Work Order ID 132265

Item Name: Crosstube Turning Detail

DART AEROSPACE LTD		Work Order: 132265
Description: Crosstube Assembly		Part Number: D407-667-145
Inspection Dwg: D407-667-145 Rev: C		Page 1 of 2

DRAWING NO. D407-667-145	TITLE CROSSTUBE ASS'Y (407 HIGH FWD)	REV. C	DART AEROSPACE LTD ENGINEERING ORDER		D.E.O. NO. D407-667-145-C-1	SHEET NO. SHEET 1 OF 1	SCALE NTS
DRAWN <i>qp</i>	CHECKED <i>ASS</i>	MFG. APPR. <i>IB</i>	APPROVED <i>WD</i>		DE APPR. <i>HA</i>		
DATE 11.07.15	DATE 11.07.22	DATE 11.07.22	DATE 11/07/22		DATE 11.07.21

DETAIL P
 BONDING STRAP INSTALLATION 2 PL

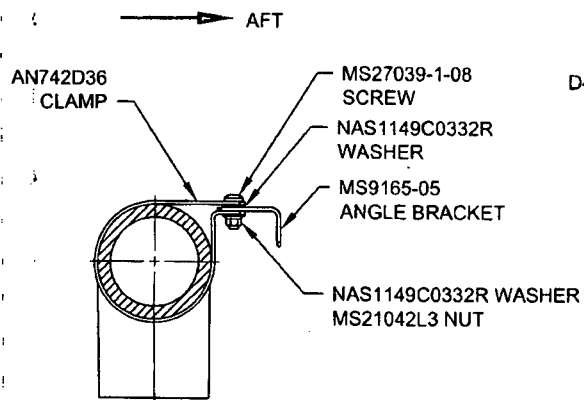
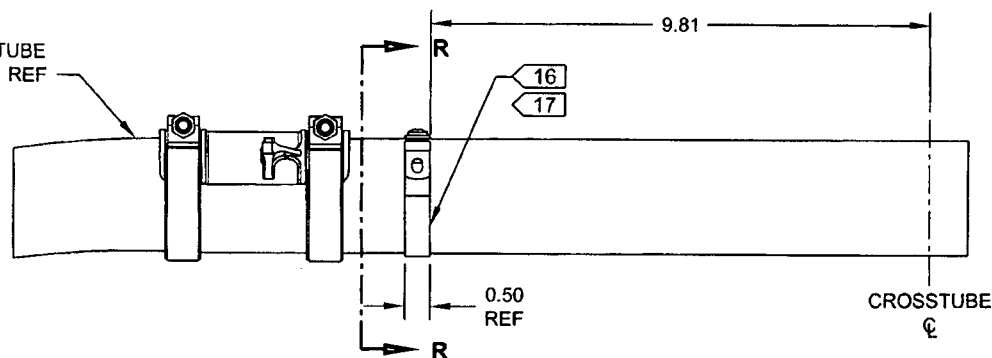
PURPOSE:

ADD ELECTRICAL GROUNDING STRAP

CHANGE:

ITEM	QTY -145	PART NUMBER	DESCRIPTION
1	X	D407-667-145	CROSSTUBE ASSEMBLY (407 HIGH FWD)
10	2	AN742D36	CLAMP
11	2	MS9165-05	ANGLE BRACKET
12	2	MS21042L3	NUT (OR MS21042-3)
13	2	MS27039-1-08	SCREW
14	4	NAS1149C0332R	WASHER (OR AN960C10L)

- 16) MASK AREA UNDER CLAMP PRIOR TO PAINTING
- 17) SEAL EDGES WHERE AN742D36 CLAMP MEETS WITH THE CROSSTUBE USING SIKAFLEX-241/-291 OR MIL-S-8802 CLASS B2 OR PROSEAL 890 SEALANT
- 18) PERFORM RESISTANCE CHECK TO ENSURE MAX RESISTANCE IS 10 MILLIOHMS
